# The Crestview Apartments Project

Final Environmental Impact Report  
SCH#2020069047

This Response to Comments (RTC) section provides responses to public and agency written comments received by the City of Riverside on the Draft Environmental Impact Report (DEIR) for the proposed Crestview Apartments Project (Project). The DEIR identifies the likely environmental consequences associated with development of the proposed Project and recommends mitigation measures to reduce potentially significant impacts. In addition to providing responses to public and agency comments received on the DEIR, this RTC document also makes revisions to the DEIR to clarify or amplify the existing analysis, as necessary, in response to those comments or to make clarifications to information presented in the DEIR.

**Fig 1: Lines (pink from SCWP vista point #1; white from SCWP vista point #2) show the undisturbed line of sight over the project site to the Box Springs Mountains. The project will create a huge 50ft high complex in this otherwise undisturbed viewscape.**

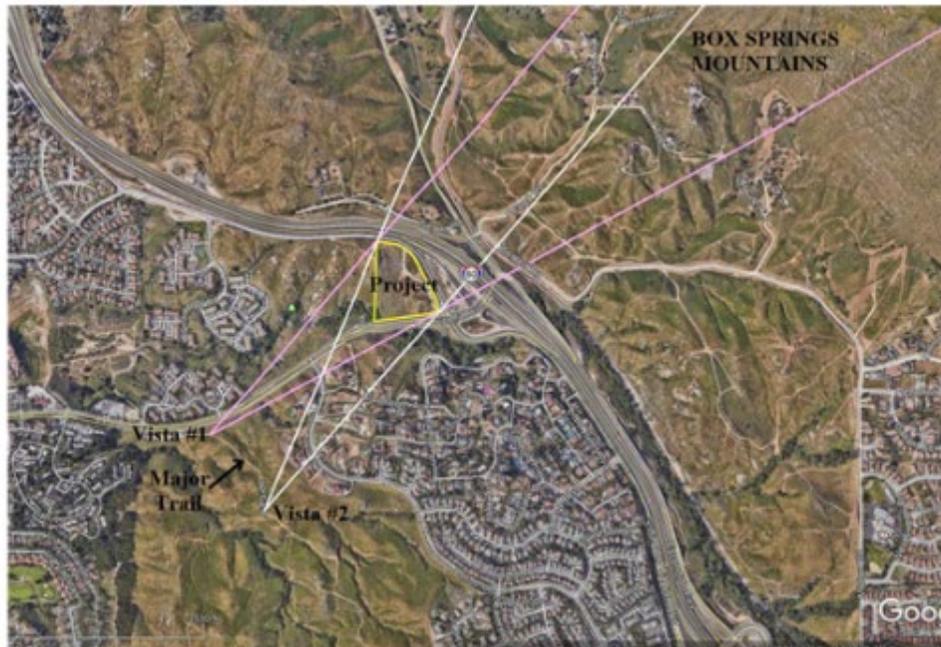
Second, the height (approximately 50ft) of these buildings is entirely inconsistent with the viewscape in the area. In particular, SCWP is a very heavily used park, with the major point of entry on Central Ave, west of the project. From the parking area, a major trail first heads up hill towards the project and then follows the high ground south (see Fig 1 map). This stretch of trail provides dramatic views of the Box Springs Mountains to the east, looking over the project site. The project will severely impact this viewscape. Part of the line of sight does cross a few, largely hidden, single story homes, but the view is otherwise entirely undisturbed by buildings.

9.8

The commenter cites DEIR Figure 5.1-5 to support the commenter’s argument of an “extreme degree of staircasing” that would impact scenic vista views. However, based upon Figure 5.1-5, the commenter’s description appears to be exaggerated and out of appropriate visual context. The view of the proposed Project’s walls and 2:1 slopes depicted in DEIR Figure 5.1-5 is provided from a relatively close-up overhead view. If Comment 9.7 is to be understood, the commenter’s concern stems from proposed Project walls and 2:1 slopes significantly impacting scenic vista views from trails in the SCWP in addition to impacting public views for those traveling/biking/exercising along Central Avenue. However, the commenter fails to provide adequate evidence or an explanation for how these impacts to public views along Central Avenue would occur other than to state the “extreme degree” of “staircasing” would have a “major impact on the landform.” As previously discussed in Response 5a.2, the proposed Project would not significantly impact public views of QROS Park from Central Avenue (refer to Response 5a.2 for a more detailed discussion). Moreover, potential impacts to scenic vista views from the SCWP due to the “extreme degree” of “staircasing” stated in reference to DEIR Figure 5.1-5 would not be as significant or “extreme” as the commenter implies. As discussed in Response 9.5, implementation of the proposed Project would not significantly impact views from SCWP of QROS Park or the mountain views beyond. Due to factors such as distance, topography, and existing development, views of the “staircasing” the commenter identifies would be far less “extreme” and exaggerated when viewed from trails within the SCW Park than the commenter alleges based on DEIR Figure 5.1-5.

**Fig 4: Commercial Project to the immediate east of the project showing the inclusion of a 30ft wide buffer to encourage wildlife movement.**

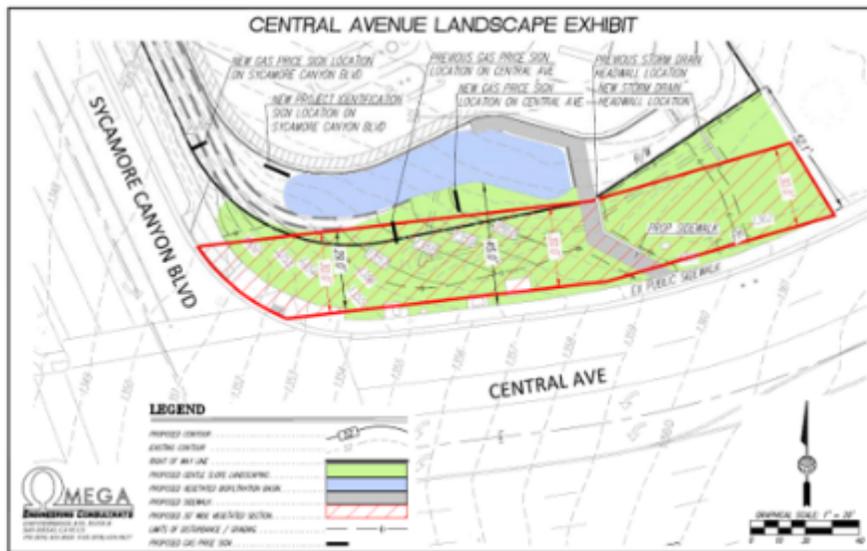
The only viable route for constrained linkage 7 appears to be from QRP along a habitat corridor following the north side of Central Ave to the Freeway underpass. The option for

such a route has already been incorporated into the design of the commercial development to the immediate east of the project. Specifically, the inclusion of a 30ft wide buffer along Central Ave with natural vegetation and minimal to no light intrusion (fig 4). In my expert opinion, it is essential that a similar 30ft (or more) buffer along Central Ave be incorporated into the project, from the western edge of the property as a continuous strip to the eastern edge at Sycamore Canyon Boulevard. This wildlife buffer should be planted with native vegetation and protected to the extent possible according to the MSHCP wildland/urban interface guidelines.
